### Staff Report & Recommendation

### Design Review Board

DATE: August 04, 2020

SUBJECT: **DRB19-0462**  
**6961-6985 Abbott Avenue, 300-326 71<sup>st</sup> Street, and 6972 Harding Avenue**

**Overall Site**

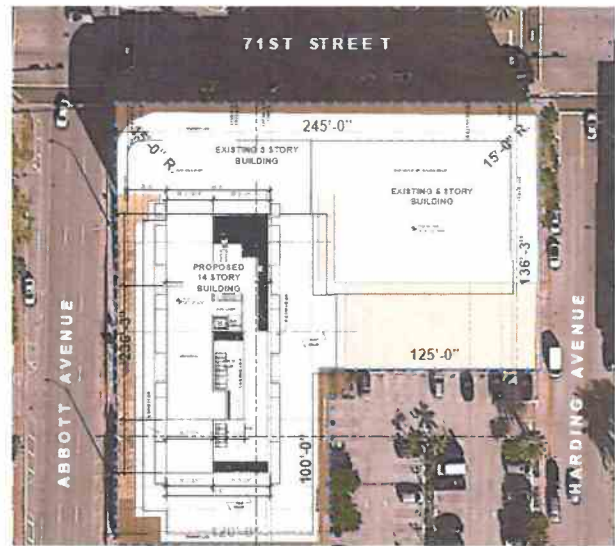
The subject site is a 1.13-acre unified development located within the boundaries of the TC-C, Town Center – Central Core District. The applicant is proposing a new 14-story, 149'-2" high building with 118 residential units above a ground floor retail component. The site is generally bound by 71<sup>st</sup> Street to the north, Abbott Avenue to the west, and Harding Avenue to the east. Except for the parcels fronting 71<sup>st</sup> Street, the rest of the site is vacant and unimproved, including a surface parking area ancillary to the bank.

As proposed, a landscaped trellis covering has been introduced to reduce the visual impact of the parking lot. However, as indicated in the variance analysis of this report, the proposed surface parking lot coupled with an undefined scope for the existing City National Building results in a gross lack of activation for the Harding Avenue frontage, which is antithetical to the development of the TC-C district. Staff is **STRONGLY OPPOSED** to the applicant's proposal to retain the surface parking lot and recommends that the applicant further explore how to utilize this area. Any surface parking areas should be located behind a structure in order to allow for activation along Harding Avenue. Staff also has concerns with the lack of adequate programming and design for the adjacent ground floor of the City National Building. Staff recommends that the redevelopment of the City National Building incorporate the opening of the ground floor and activating it with an appropriate use in order to engage the 71<sup>st</sup> Street corridor. The gross lack of activation and design along the sidewalk level of Harding Avenue and 71<sup>st</sup> Street seriously compromises the larger development project. As such, staff is recommending that the application be continued so that a more complete overall project can be presented to the DRB.

### **Driveways and Loading**

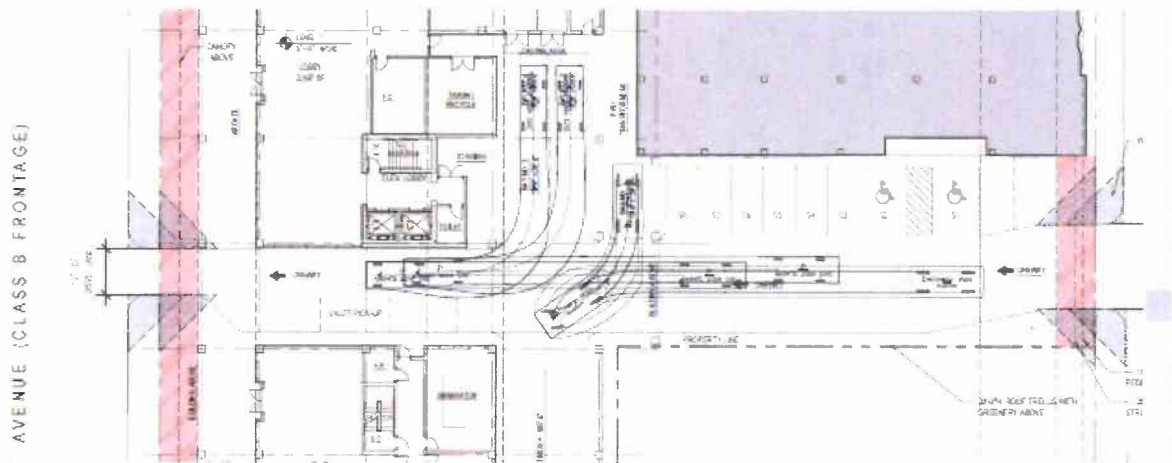
The applicant is seeking a waiver to allow a driveway on Abbott Avenue (a Class B street) when Harding Avenue (a Class C street) frontage permits a combined driveway. It is not uncommon for development projects that contain two north-south bound streets to request a waiver of the development restrictions from permitting a driveway onto Class B street frontages. The following three roadways are classified as Class B frontages within the TC-C: Abbott Avenue, Dickens Avenue and 69<sup>th</sup> Street. The subject site is part of combined Blocks E and 12 which spans from 69<sup>th</sup> Street to 71<sup>st</sup> Street and were historically platted without a 70<sup>th</sup> Street crossing right-of-way. The total length of this super block measures 601'-4" in length. However, in this instance, since the subject block contains frontage that does not contain 260'-0" in length, and while the DRB can waive the requirement, staff is not supportive of the waiver request. The Abbott Avenue frontage is 251'-0" of linear frontage including the existing Gidney building site.

As previously mentioned, staff is strongly opposed to the proposed ground floor site plan, as it includes the retention of the existing surface parking area. To allow the waiver to add a driveway onto the Class B street (Abbott Avenue) would be an endorsement of the undeveloped site plan as it pertains to vehicular maneuverability. The proposed site plan repurposes the existing surface parking area behind CNB building and restripes it for parking, adds an outside loading space and acts as a drive through access to the building.
